SUBJECT: Summary of 940324 public meeting w/util to discuss Steam generator replacement & fuel reload changes for 1996.Agenda encl.

Subject: Public Meeting on March 24, 1994 to discuss  
Steam Generator Replacement and Fuel  
Reload Changes for 1996  
R.E. Ginna Nuclear Power Plant  
Docket No. 50-244

**GINNA STATION  
STEAM GENERATOR REPLACEMENT**

**NRC STATUS UPDATE**

**R.E. Ginna Steam Generator Replacement  
Comparison of Existing vs. Proposed**

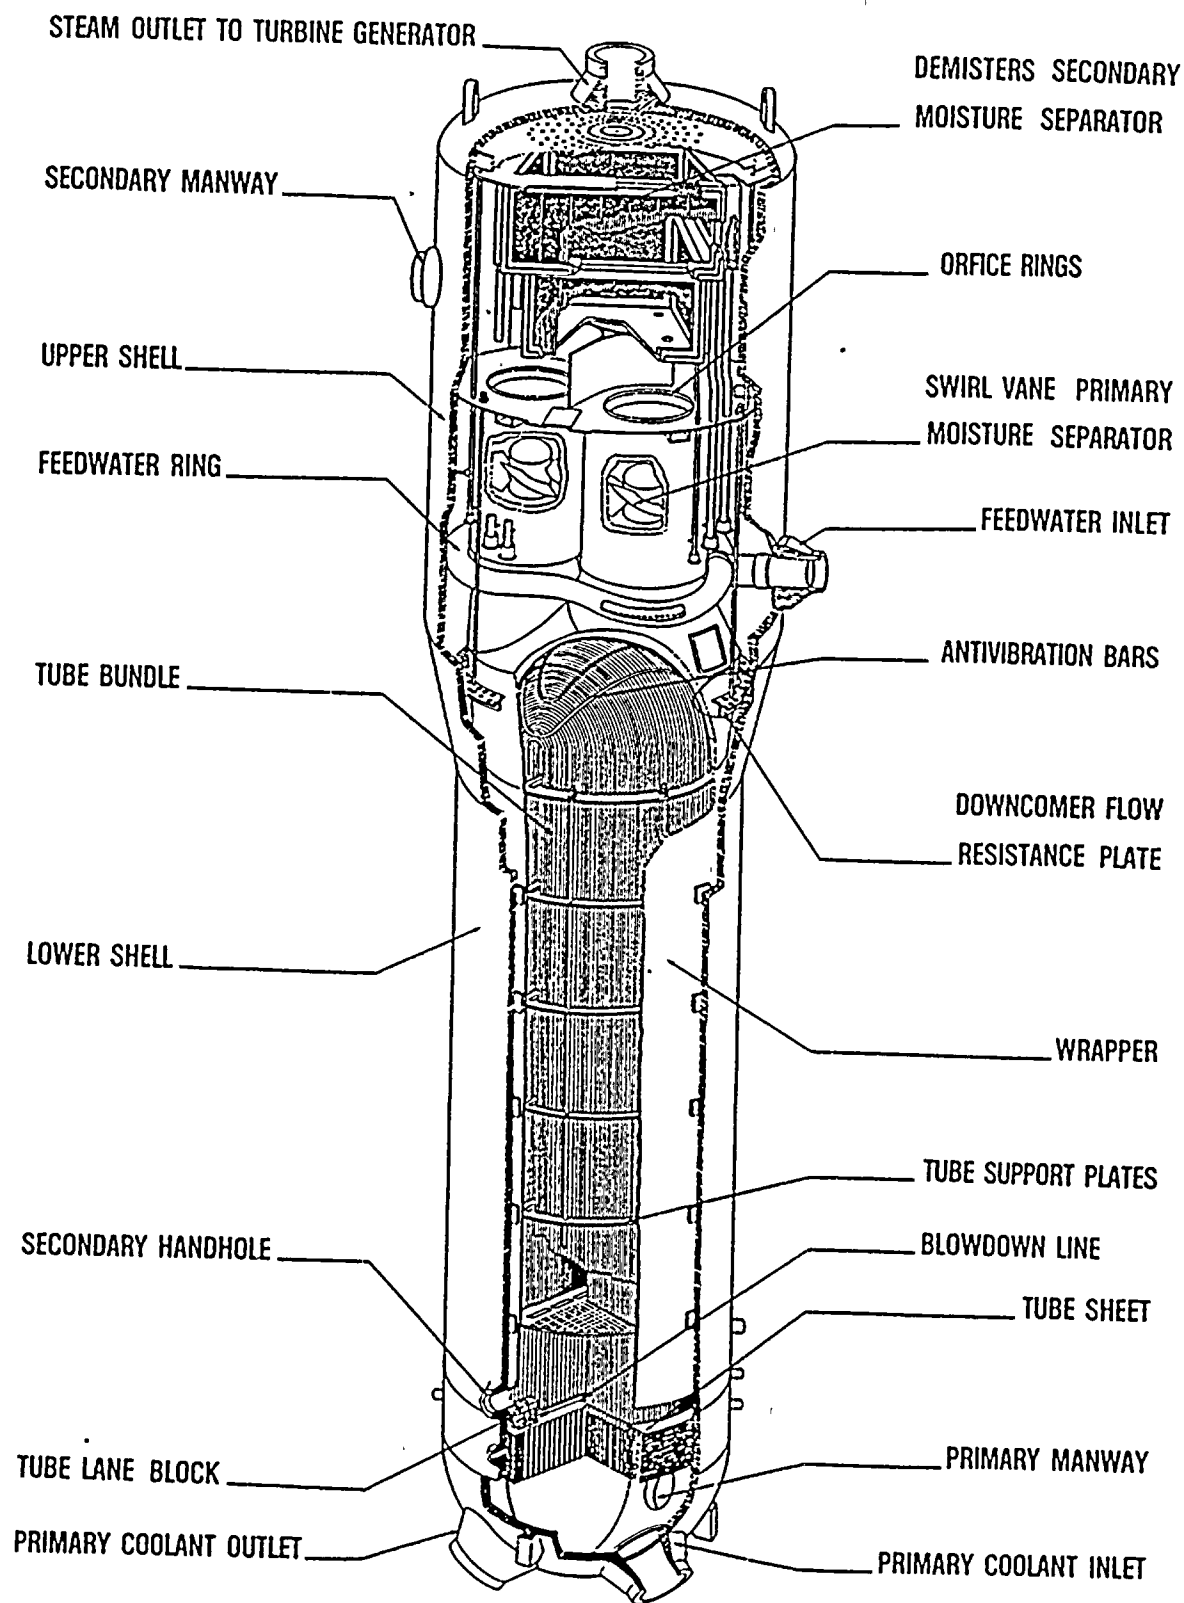
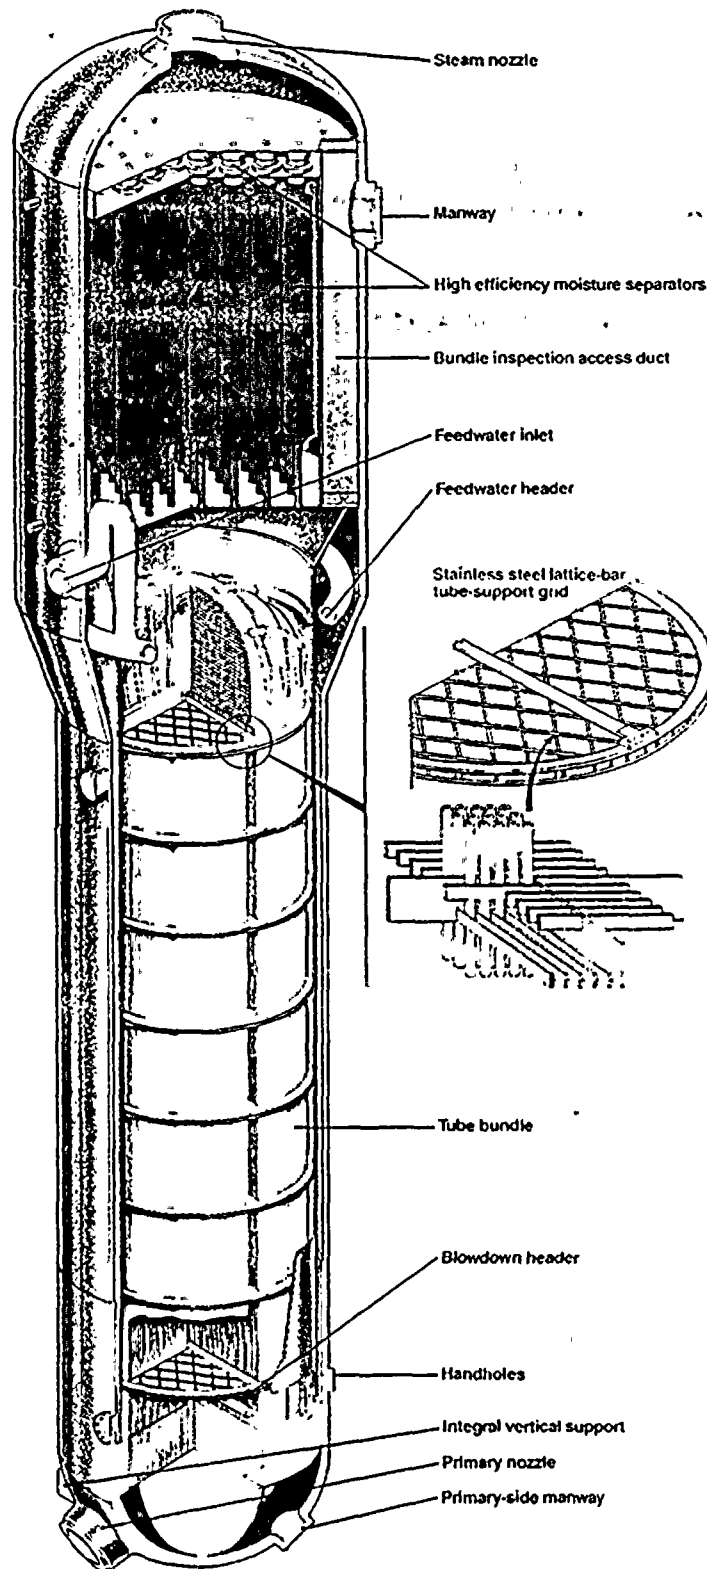
RG&E presented a comparison of the existing and replacement steam generators. The staff noted that the generators appear very similar. RG&E discussed the preliminary safety evaluation of the replacement steam generator design, and the detailed thermal hydraulic models of the primary system and containment being developed to reanalyze some of the UFSAR transients. The staff questioned the need for detailed models, given the similarities of the generators.

## REACTOR COOLANT SYSTEM

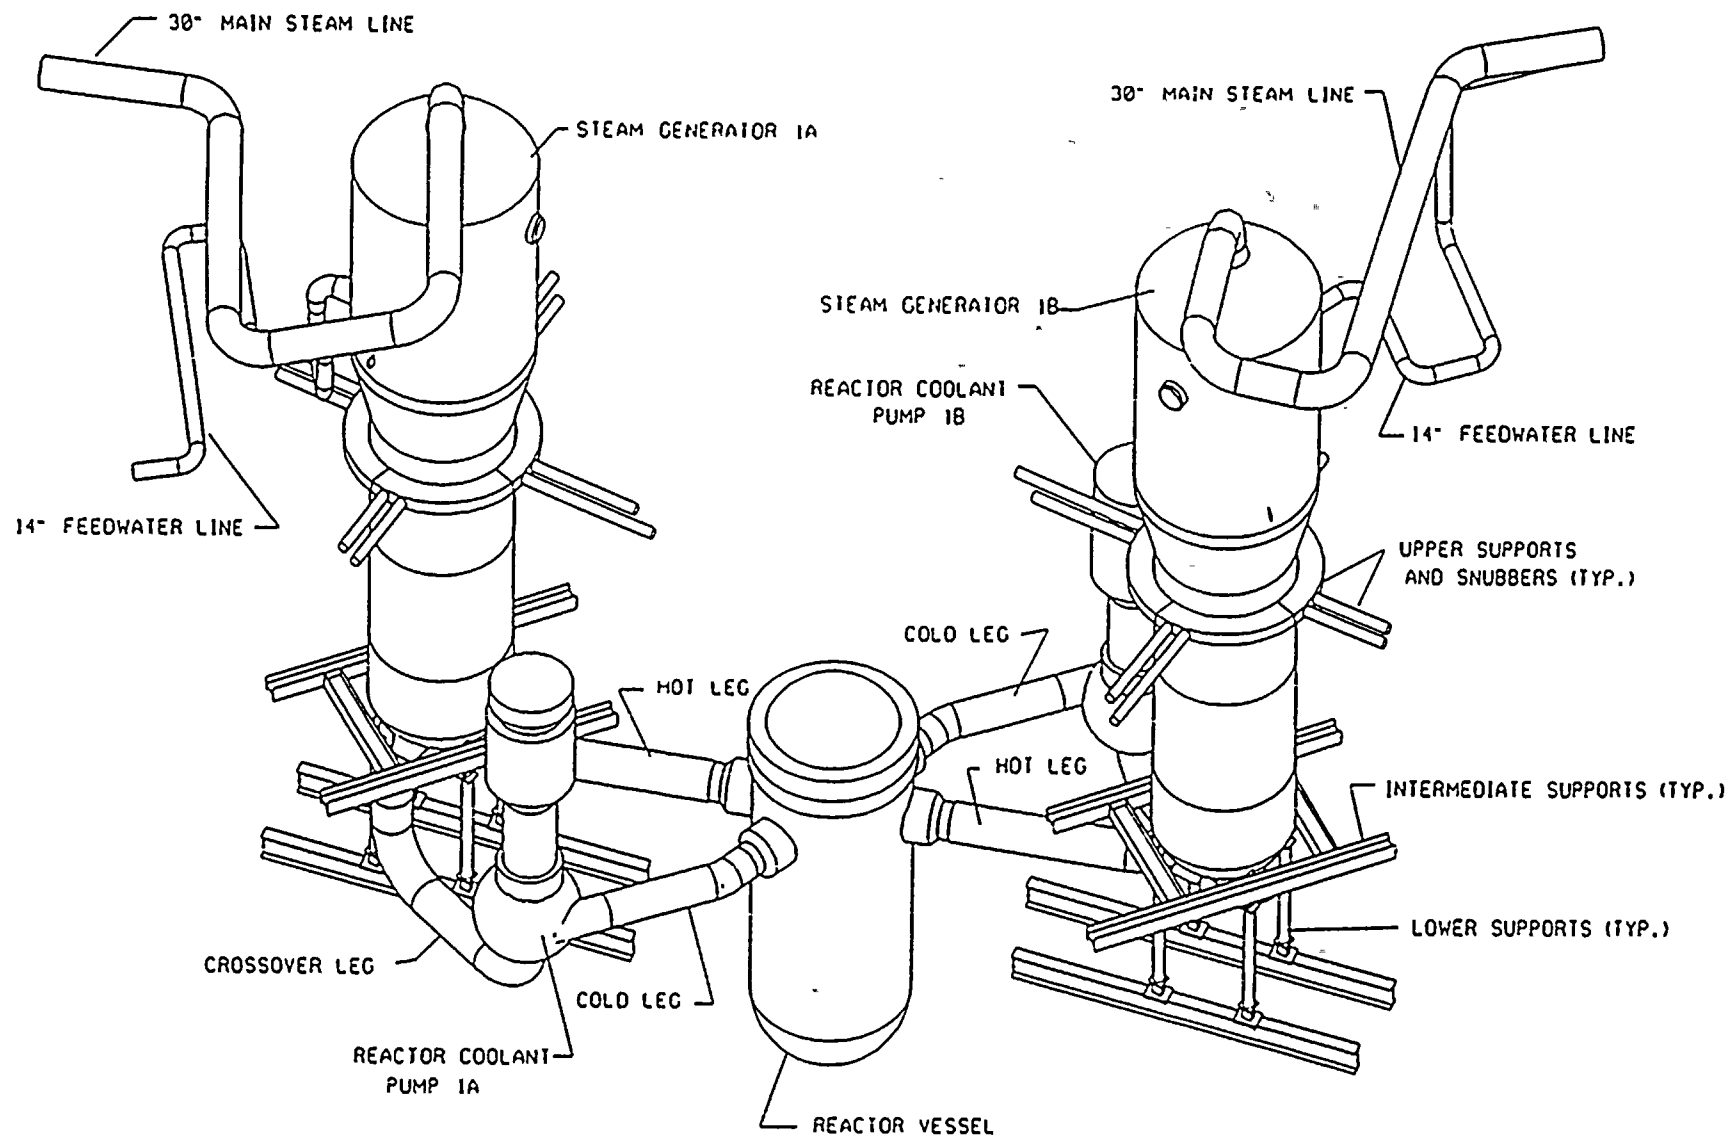
RG&E outlined the intended methods to be used for the structural evaluation of the restored reactor coolant system. Specifically, RG&E intends to include explicit modeling of walls and supports when analyzing the restored system. The staff cautioned that while this appears acceptable, close attention should be given to this to ensure that consistent and conservative modeling of the wall-RCS interfaces are made, particularly with respect to damping factors. RG&E also presented information on a displacement model of the reactor coolant system developed to help predict pipe movement during cutting activities. The staff was questioned as to the appropriateness of using temporary supports or restraints, but it was agreed that further detail would be needed before a response could be provided.
